Topics:

Aiwu Zhang 03/14/2016

EIC Tracking R&D Monday meeting

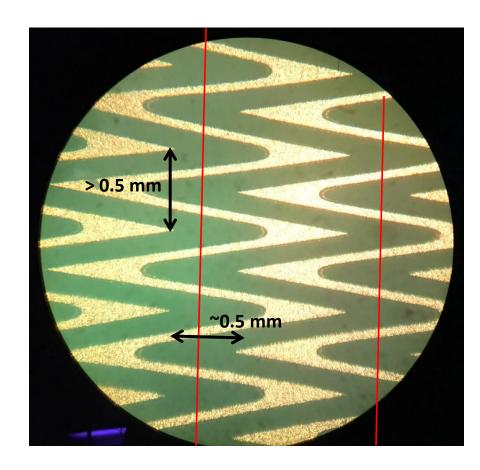
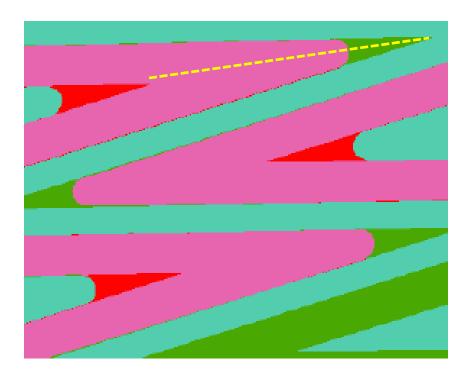
The "over-etched" length (for one strip) is about 0.3 mm, this needs to be compensated in the design.

[vertical tip distance should be 0.5 mm, and is slightly larger than 0.5 mm by measuring] [the ~0.5 mm is measured with a caliper under a magnifier]

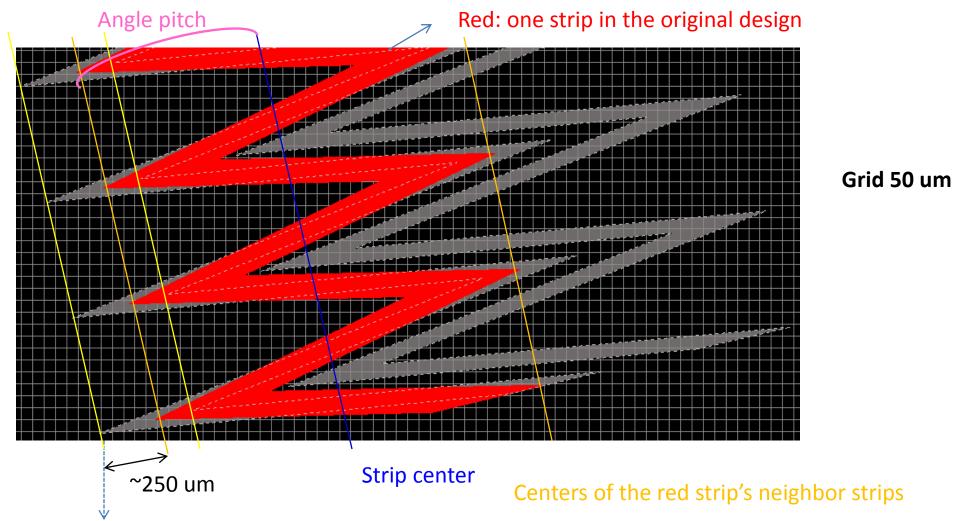
Green: the original design
Pink and red: tips get rounded (with
radius 1.5-2 mils, or 38-50 um).
Per ACE engineer's experiences, the tips
were rounded by 1:1 (outer radius) or
1.5:1 (inner radius) [ratio is over the
thickness of the feature (copper) based
on 2 oz or 36 um]

To compensate the "over-etching" problem, the proposed structure should interleave more into neighbor strips.

(in this design, it interleaves **30% more** of the pitch angle at outer tips, corresponds to ~250 um; the inner tips interleave **80% of** the pitch angle, to maintain reasonable line width and gap: ~50 um.)
